TYPE NO 7100 ES - FB - IN	TYPE Coffe Vending Machines	T.I. NO 03 - 2015				
SERIAL NUMBERS AFFECTED From and including S/N 41711049 (7100ES)	ISSUED BY Documentation/N&W Valbrembo					
SUBJECT STAINLESS STEEL STUDS FOR CUP STOP		ISSUED FOR (X): <table border="1"> <tr> <td>Action</td> <td><input type="checkbox"/></td> </tr> <tr> <td>Information</td> <td><input checked="" type="checkbox"/></td> </tr> </table>	Action	<input type="checkbox"/>	Information	<input checked="" type="checkbox"/>
Action	<input type="checkbox"/>					
Information	<input checked="" type="checkbox"/>

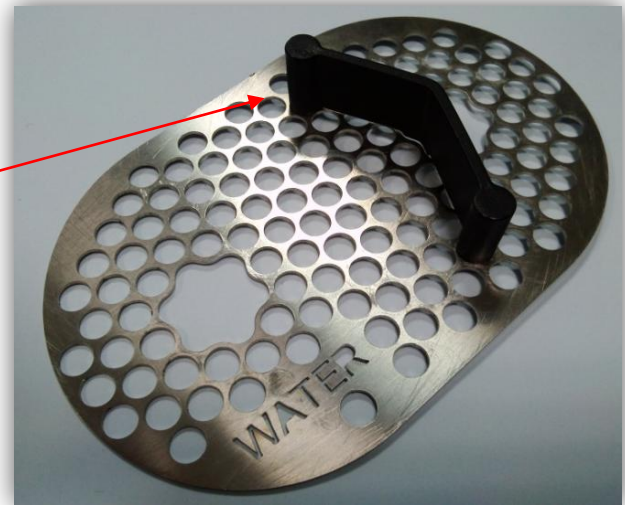
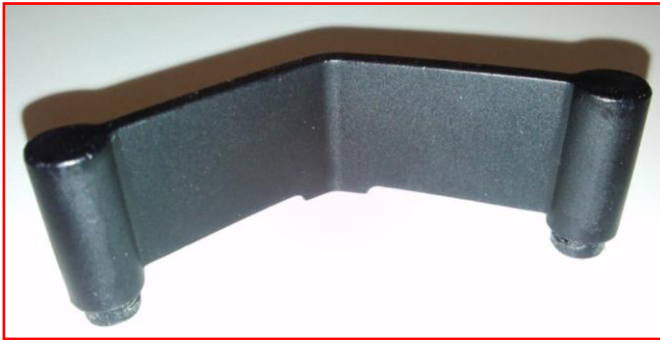
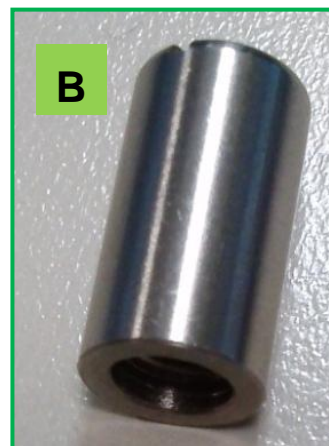
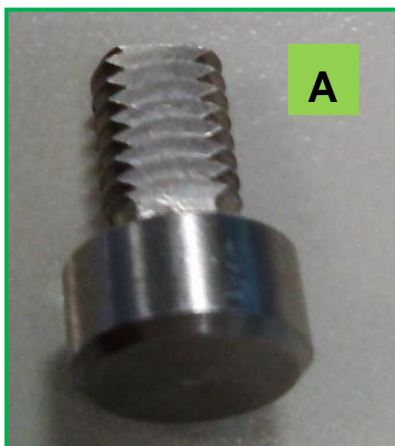
The existing CUP STOP solution does not guarantee a good fixing.

A new solution has been introduced.

Below two pictures of the old CUP STOP

The new CUP STOP is made by :

- n. 3 "cup stop male thread pin (A) - Spare part code: **259068**
- n. 3 "cup stop female thread pin (B) - Spare part code: **259067**

The new cup stop solution guarantees a good fixing, thanks to the three fixed points.

The new cup stop solution can be installed in the machines prior to the above mentioned serial number.
